10/523,972

Eiji Kadouchi

Office Action Summary

DETAILED ACTION

Fig. 44

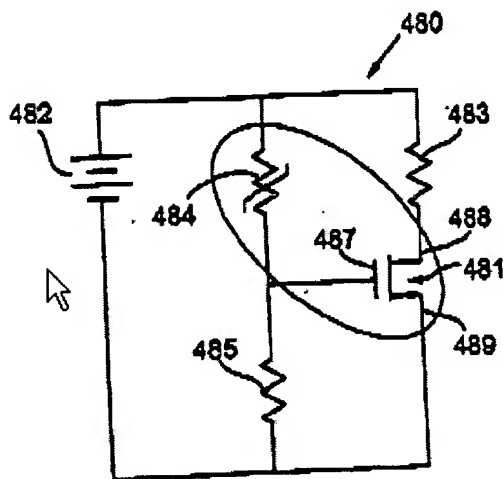
Thomas discloses in Figure 44, and paragraph 0193, a heating resistor increases automatically so that heat generating current stops, and the independent discharge circuit is electrically connected to the battery (see below)

[0193] In accordance with this aspect of the inventions disclosed, PTC device 484 is thermally coupled to the FET device 481 as a protection against failure of the FET device 481 in case of overcurrent. As the voltage across the PTC device 484 and, therefore, the voltage across the FET device 481, approaches a level that might otherwise cause the FET device 481 to fail, current flowing through the PTC device 484 will suffice to raise the temperature of the PTC device 484 to its trip temperature. Once PTC device 484 trips to its high resistance state, the voltage across the device 484 will immediately drop to a level below the threshold gate voltage of the FET device 481, causing the FET device 481 to turn OFF.

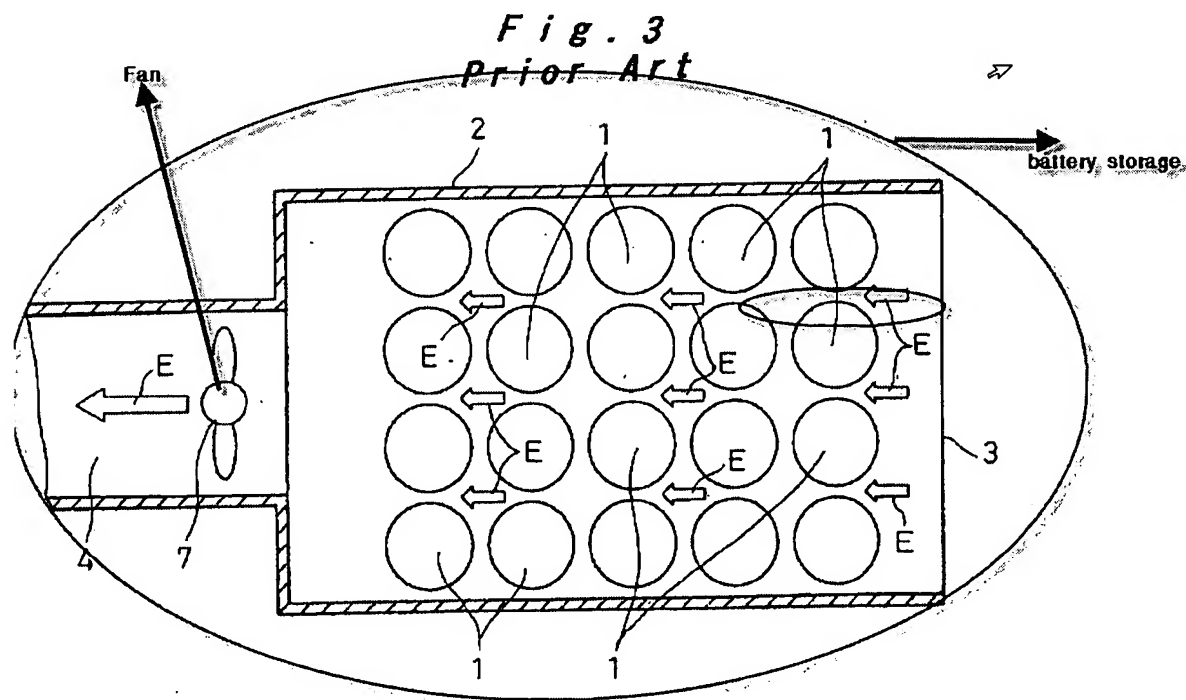
Regarding Claim 14, Oshida discloses in Figure 22, a plurality of heat conducting fins (152), a heat conducting body (154) located at said opening for conducting heat

between said plurality of fins, wherein said heat conducting fins communicate with said heat conducting body.

It would have been obvious to a person having ordinary skill in the art at the time of the invention to modify the opening of Hashiguchi's system and add a heat conducting plate and fins as taught by Oshida to provide exchange heat highly and efficiently.
